Subject: Timberline Village #628 Water System, ID #88388, Lewis County  
Water System Plan Part B Update, ODW Project #23-0706

Thank you for your review of the Timberline Village 628 Water System Plan (WSP) Update. Please see the following clarifications and updates below which are provided in response to the comment letter dated December 15, 2023:

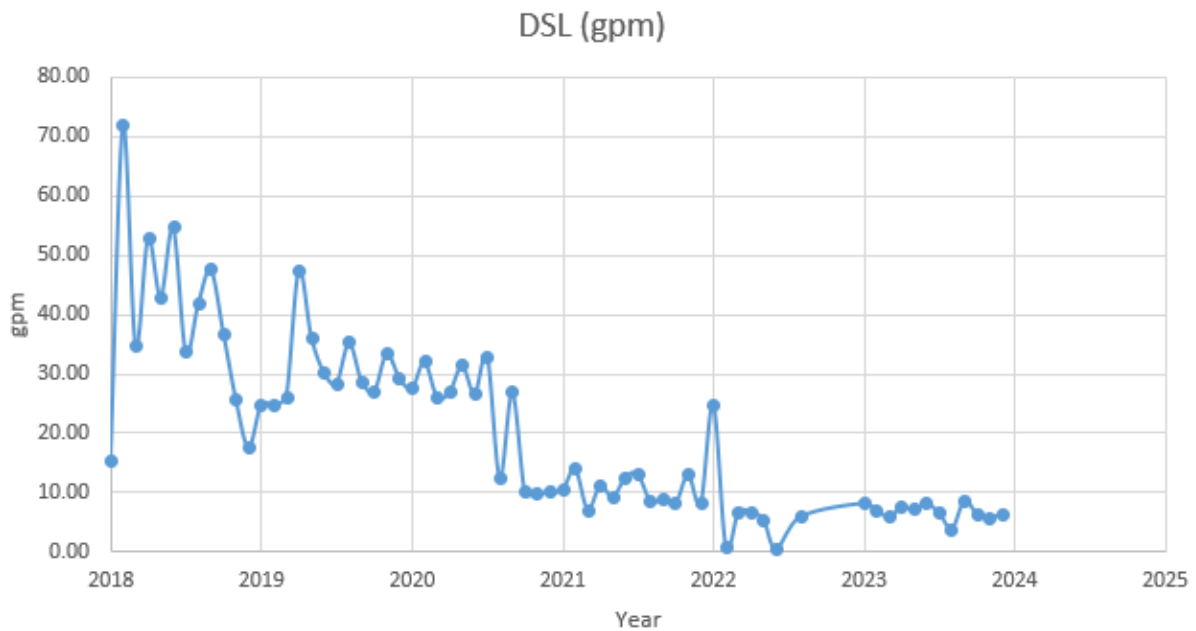
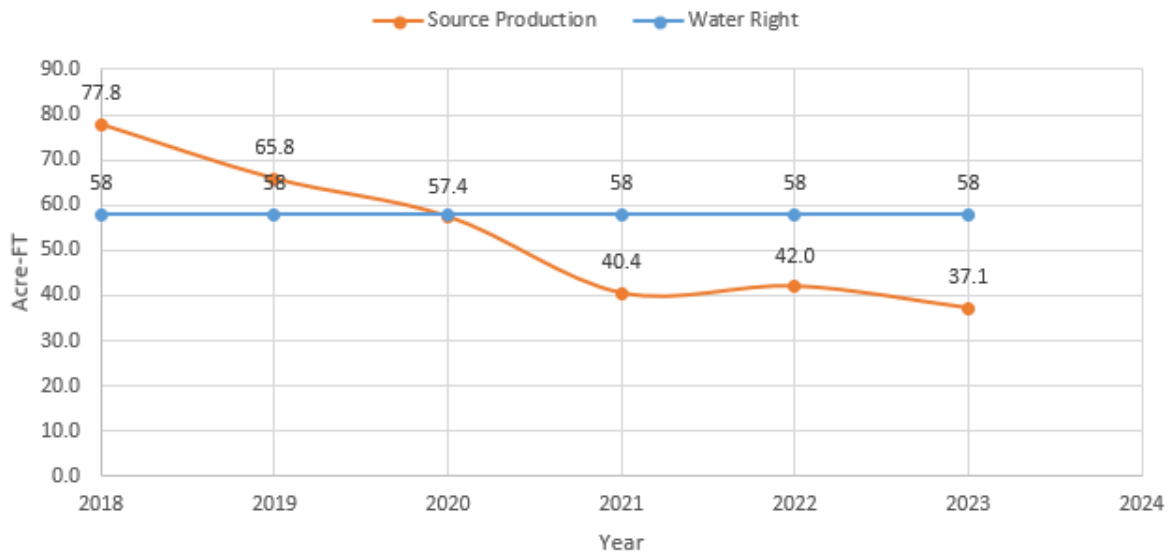
Before closing this letter, Thurston PUD would like to provide a brief update on the past year's water use and DSL. Total source production for the year 2023 was 37.1 acre-feet, well within the 58.0 acre feet authorized under the water right certificates. Of this total source production, 26.5 acre feet was sold to customers, with an average leak loss rate of 6.67 gpm. We believe that this leak loss rate exemplifies the success of the PUD's ongoing efforts. We also believe that these 2023 statistics further support the planning projections of the WSP and show the Timberline Village water system continuing in its positive historical trend of reduced DSL since acquisition by Thurston PUD. Below are figures from section 2.2.3

of the WSP with the addition of 2023 data; please see WSP section 2.2.3 for further information regarding these figures.
